NATIONAL TRANSPORTATION SAFETY BOARD

Group Chairman's Factual Report

WPR12MA034

EMERGENCY ALERT SERVICE BULLETIN

The flowchart below is intended to help you understand paragraph 1.E.2.

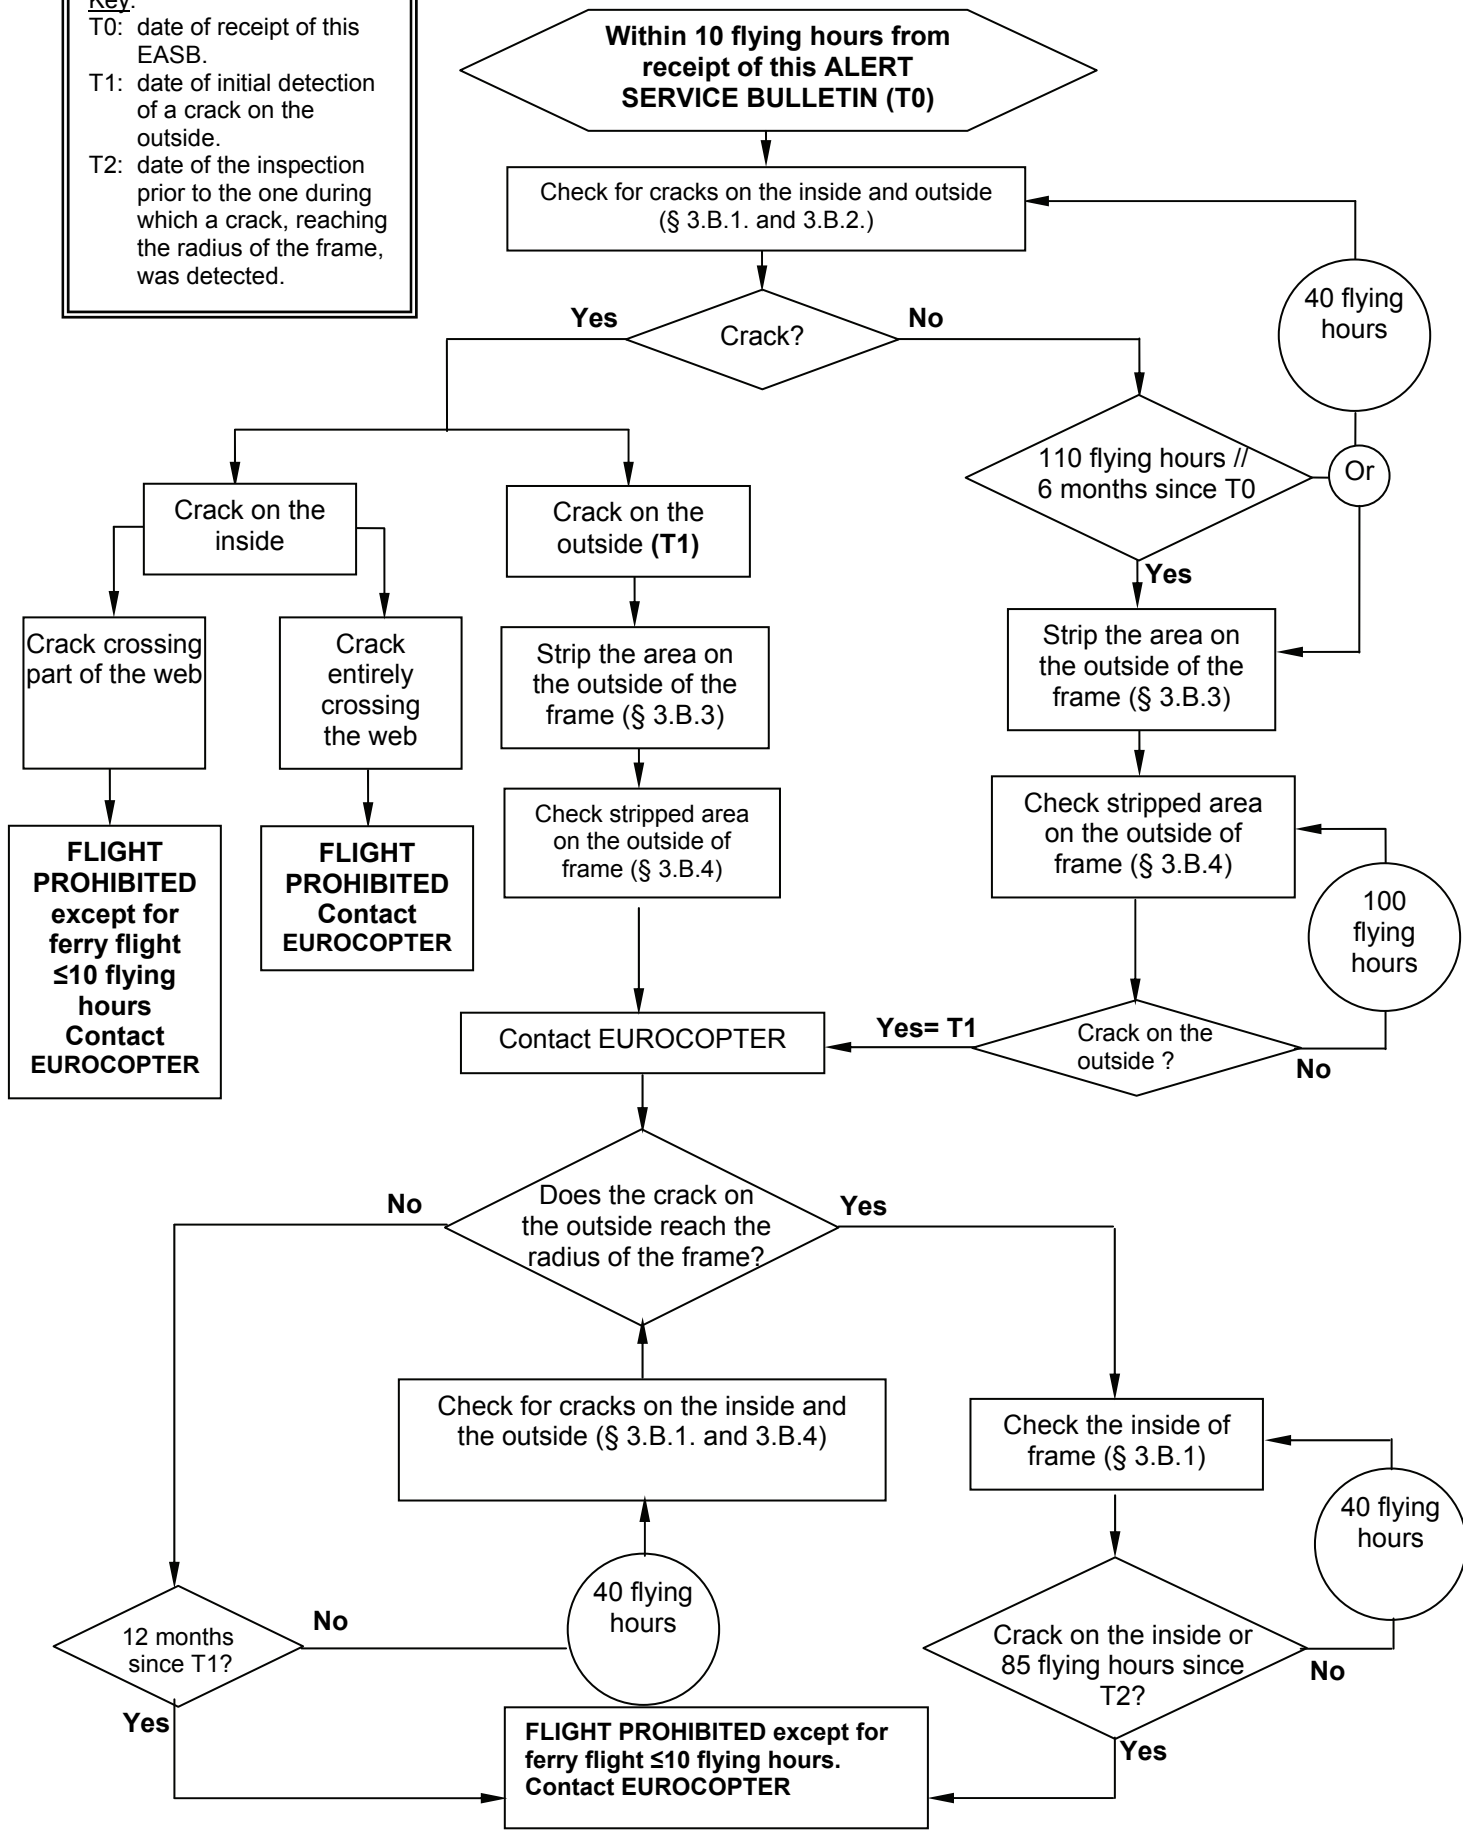
- a) **Within 10 flying hours following receipt of this ALERT SERVICE BULLETIN:**
· Comply with paragraph 3.B.1. and 3.B.2. pending compliance with paragraph 3.B.3. and 3.B.4.

- b) Within 110 flying hours without exceeding 6 months following receipt of this ALERT SERVICE BULLETIN:
· Comply with paragraph 3.B.3. and 3.B.4. successively.

Figure 1

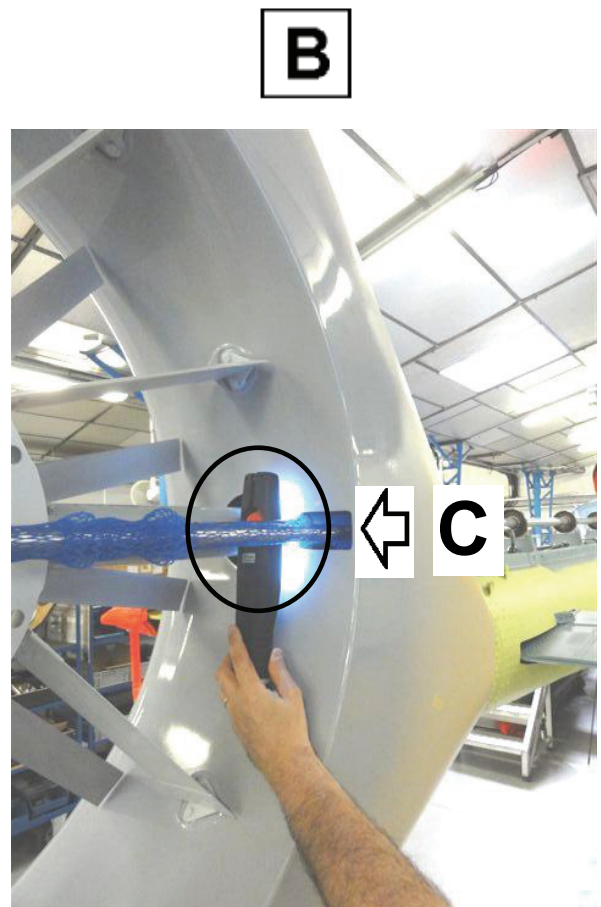
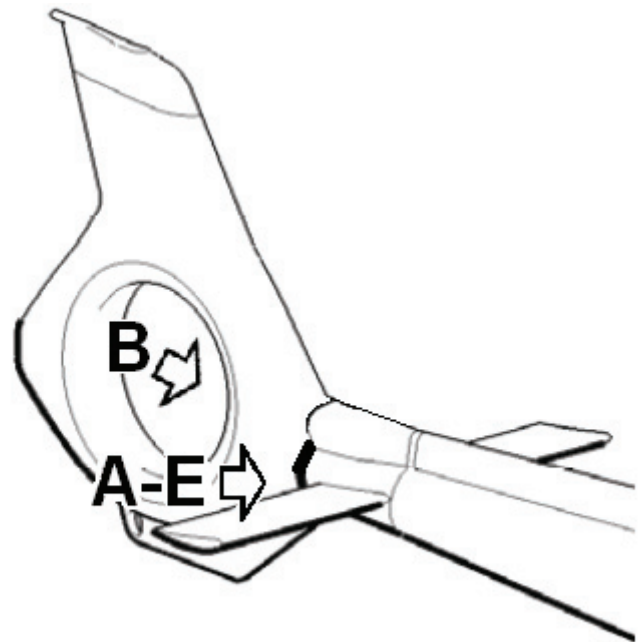
- Check that there is no crack in the web (c) of frame (a) on the RH side (Details C and D, Figure 2) using a light source positioned in front of the opening of the drive shaft tube and by looking through the yaw control opening in the Fenestron (Detail B, Figure 1).

- Check that there is no crack on the external surface of junction frame (a) (Detail A, Figure 1).
- Interpret the results in accordance with paragraph 1.E.2. a).

Figure 2

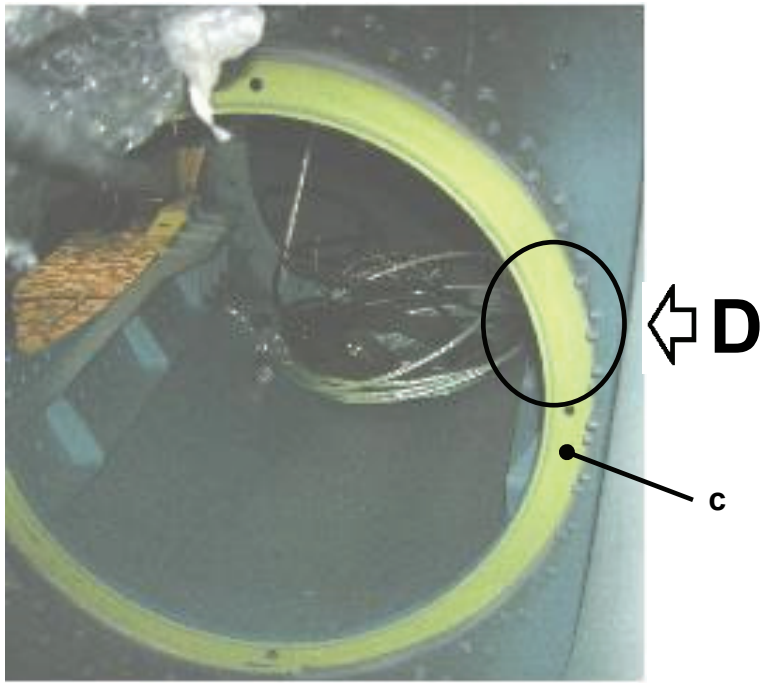
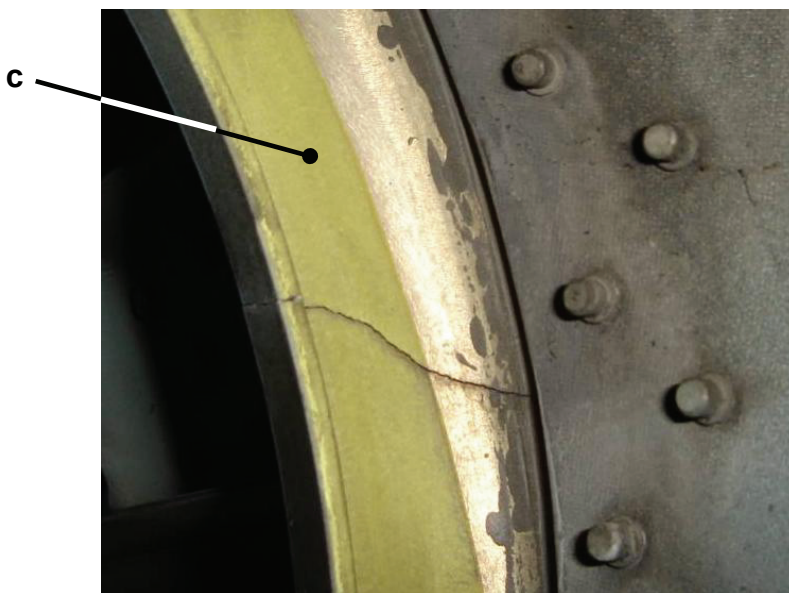
The cracks start in the plane of the rivet head countersinks on the RH side of the Fenestron (Detail E, Figure 3) and spread to the web of the frame (Details C and D, Figure 2).

- 1) Presence of a crack entirely crossing the web (c) of frame (a) (See detail D, Figure 2):
 - All flights are prohibited.
 - For the conditions for returning the helicopter to service, contact the Customer Service Technical Support Department. (See NOTE 5).

Figure 3

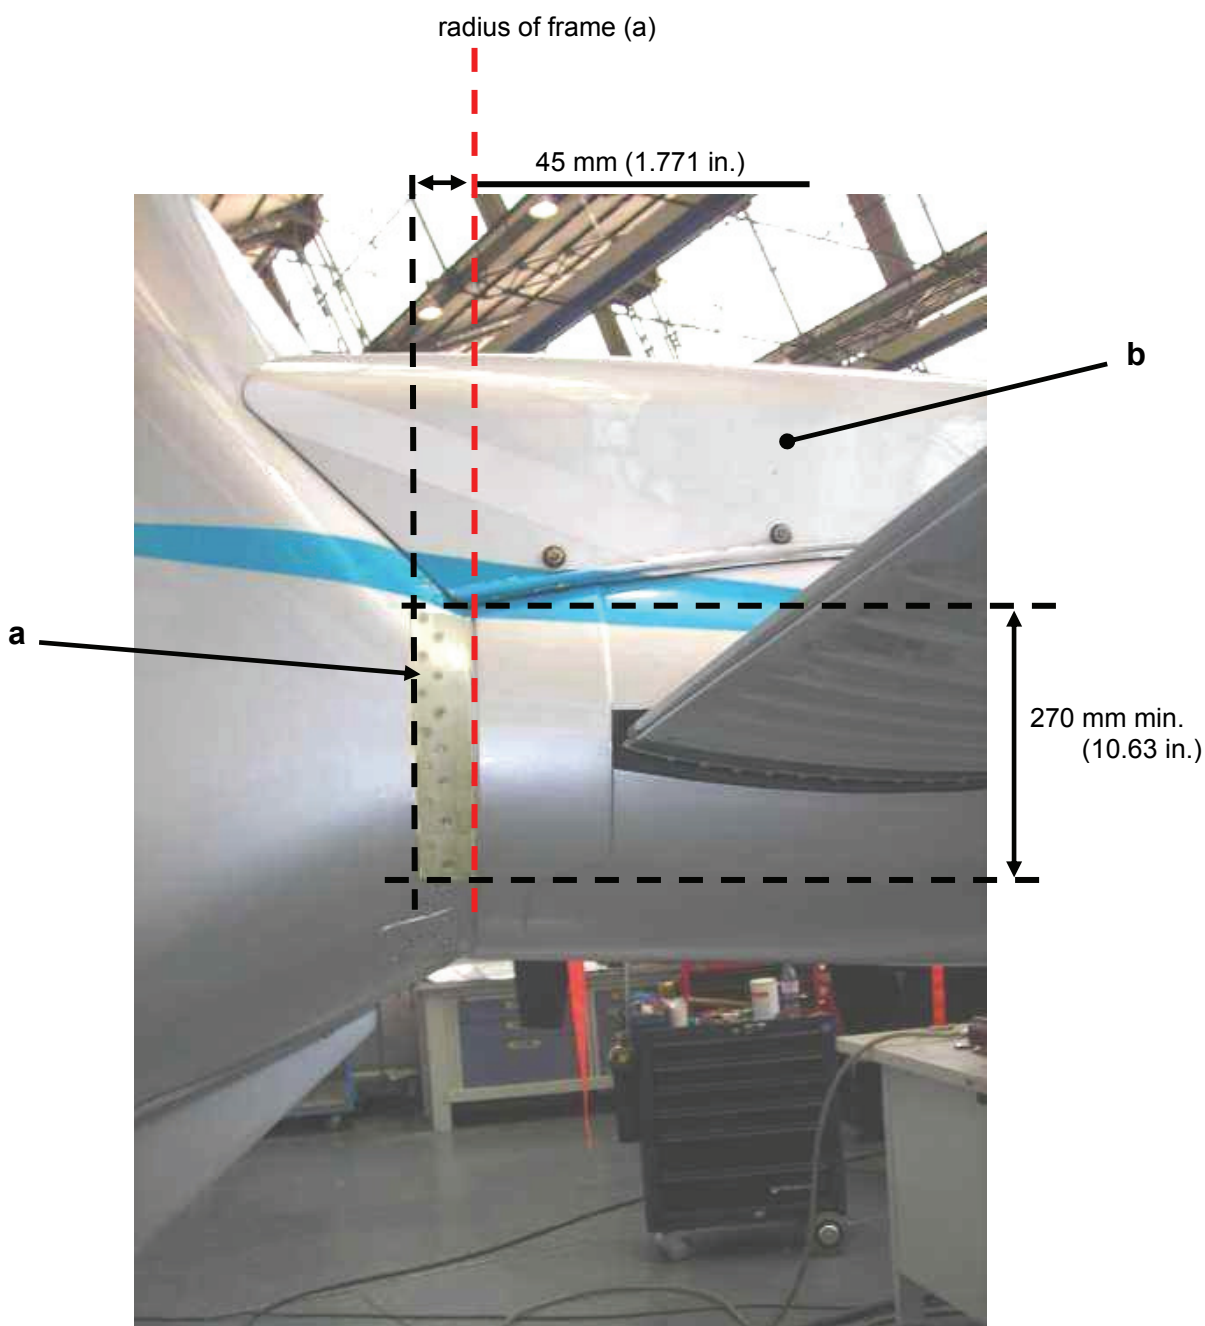
- Strip the RH side of junction frame (a) on Fenestron side, as per Detail E and as per MTC Work Card 20.04.02.401:
 - . over a length of at least 270 mm (10.63 in.) from the cowling (b),
 - . over the visible width of 45 mm (1.771 in.) from the cowling (b).
- Apply a coat of primer (1) or (2) to the stripped area as per MTC Work Card 20.04.05.402.
- Apply varnish (3) to the stripped area as per MTC Work Card 20.02.07.403.

- Check that there are no cracks in the area stripped in accordance with paragraph 3.B.3.
- Interpret the results as per paragraph 1.E.2. b).

- 1) Presence of a crack reaching the radius of frame (a) (Figure 3):
 - All flights are prohibited beyond 85 flying hours following the inspection (compliance with paragraph 3.B.4. or the flight-related check (VLV)) prior to the one during which a crack, reaching the radius of frame (a), was detected, except for the ferry flight not exceeding 10 flying hours.

- 2) Presence of a crack not reaching the radius of frame (a) (Figure 3):
 - All flights are prohibited after 12 months from initial detection of a crack on the outside of the frame, except for the ferry flight not exceeding 10 flying hours.
